Product Change Notification

PCN #: 4B-2019

DATE: 23rd April 2019

Laird Part Number	Description
451-00001	Module, BL654 Series, Integrated Antenna
451-00002	Module, BL654 Series, External Antenna
451-00003	Kit, BL654 Series, USB Adapter
455-00001	Development Kit, BL654 Series, Integrated Antenna
455-00002	Development Kit, BL654 Series, External Antenna

Figure 1: Module label

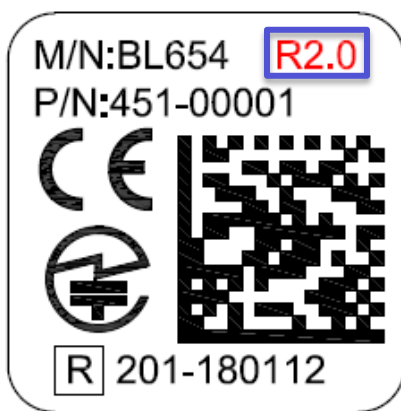
The change can be identified by reviewing the *Hardware Revision Code* number that is present on the individual module, reel label and carton label. The images below identify where this 'Hardware Revision Code' is located on each of those labels.

A Hardware Revision Code that shows as R2.0 indicates that the nRF52840-QIAA-D00 silicon is utilised.

A Hardware Revision Code that shows as R1.0 indicates that the nRF52840-QIAA-C00 silicon was utilised.
